CITY OF TACOMA Public Works Engineering Division

ADDENDUM NO. 6

REVISIONS TO: Request for Bids Specification No. PW23-0021F Links to Opportunity Streetscape – Bid Package 3

(CITY OF TACOMA	WORK ORDER NO.
		PWK-G0041-04-03
	LINKS TO ODDODTUNITY STOFFTSCADE DODIECT	AHBL JOB NO.
ed by:	LINKS TO OPPORTUNITY STREETSCAPE PROJECT	2160917.10
arson	TESC AND DEMOLITION PLAN OB STA	
BCFF4F8	229+70 TO OB STA 237+25	sheet 5 of 58

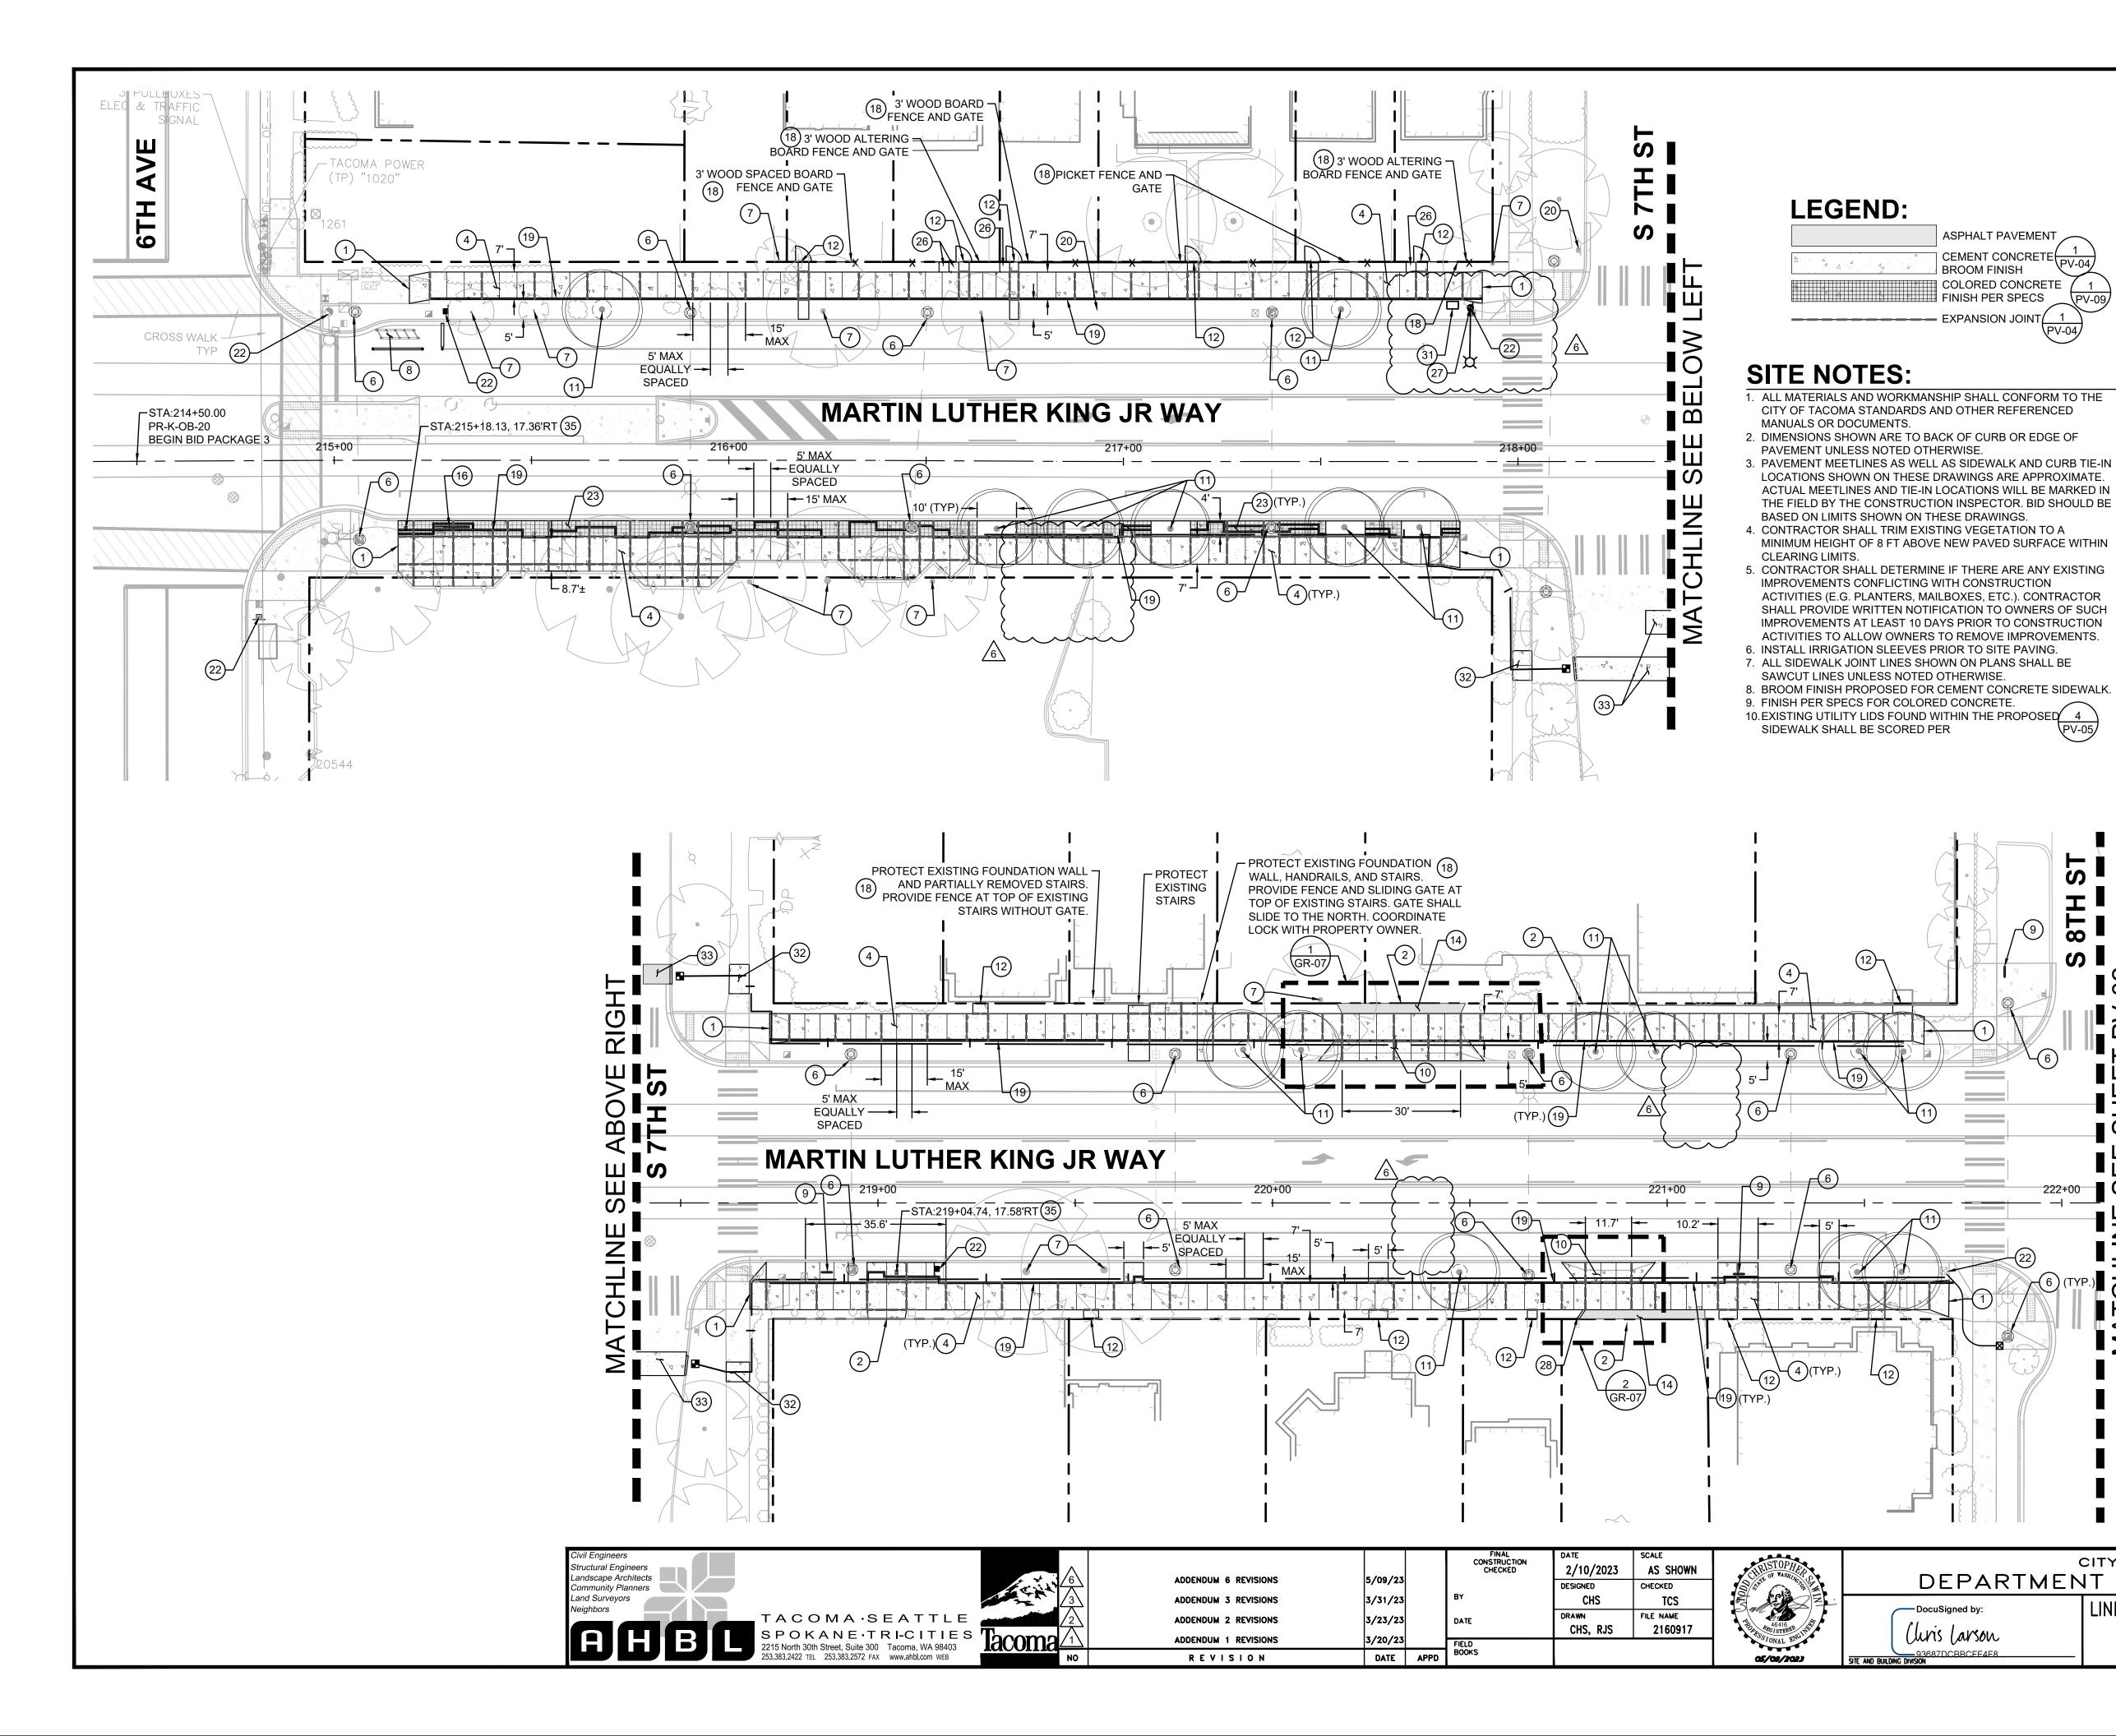
Replace Plan sheet EC-03. Updated notes and revised plan background.

PARTMENT OF PUBLIC WORKS PAVEMENT MARKING AND SIGNAGE PLAN SHEET NO. PM-02 SHEET 30 OF 58 OB STA 222+10 TO OB STA 229+70

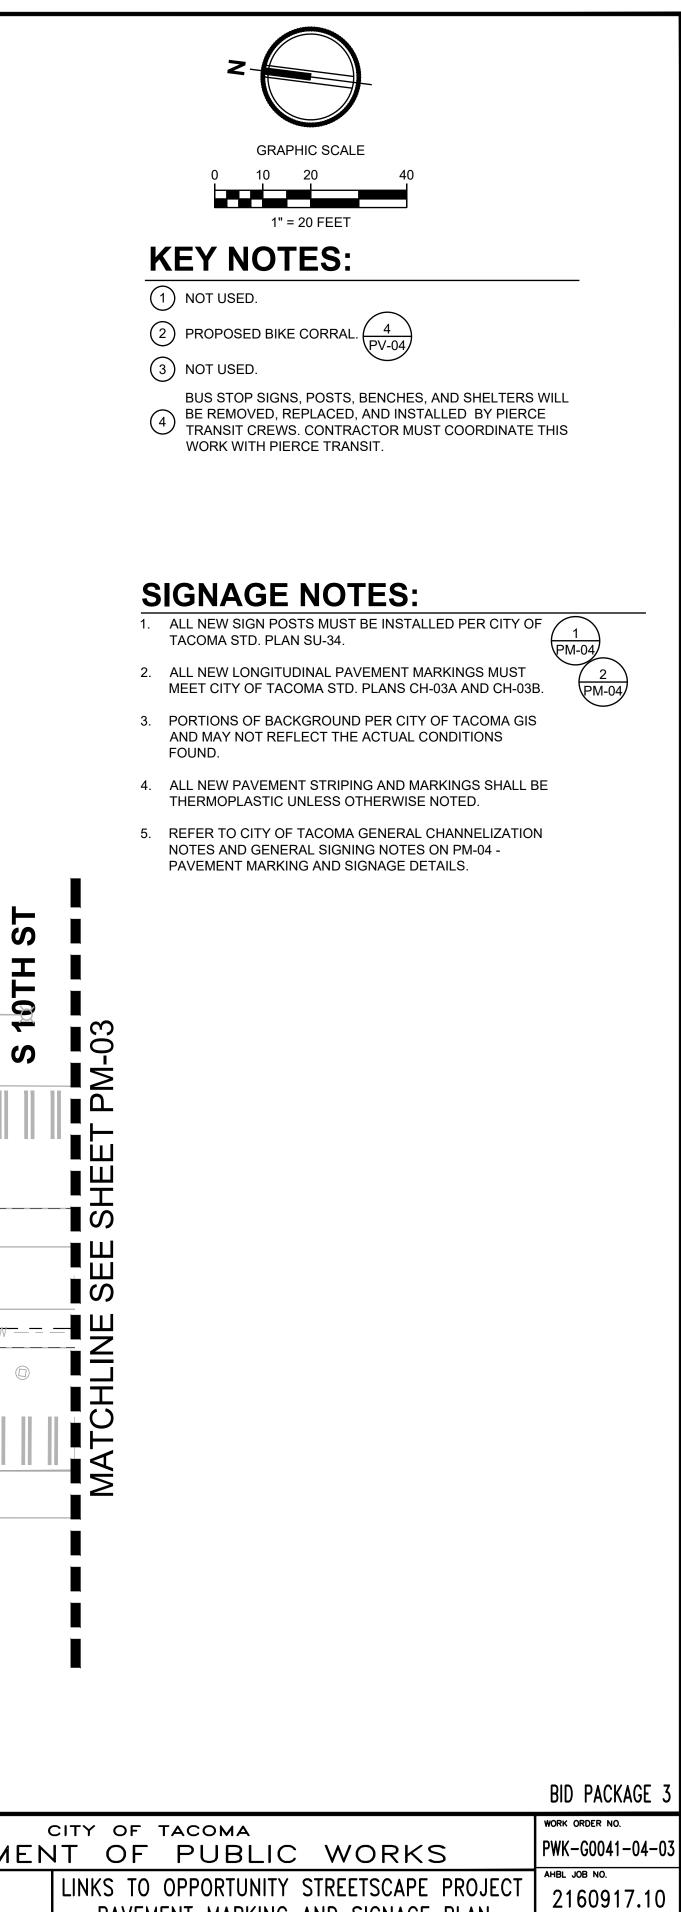
- Replace Plan sheet PV-11. Revised detail.
- Replace Plan sheet PM-01. Updated pole notes.
- Replace Plan sheet PM-02. Updated pole notes.
- Replace Plan sheet UT-01. Updated notes and revised plan background.
- Replace Plan sheet UT-02. Updated notes and revised plan background.
- Replace Plan sheet UT-03. Updated notes and revised plan background.
- Replace Plan sheet LP-04. Revised plan background.
- Replace Plan sheet LP-06. Revised plan background.
- Replace Plan sheet IR-03. Revised irrigation connection.
- Replace Plan sheet IR-06. Revised irrigation connection.
- Replace Plan sheet IL-00. Revised illumination notes and detail.
- Replace Plan sheet IL-01. Revised illumination plan.
- Replace Plan sheet IL-02. Revised illumination plan.
- Replace Plan sheet IL-03. Revised illumination plan.
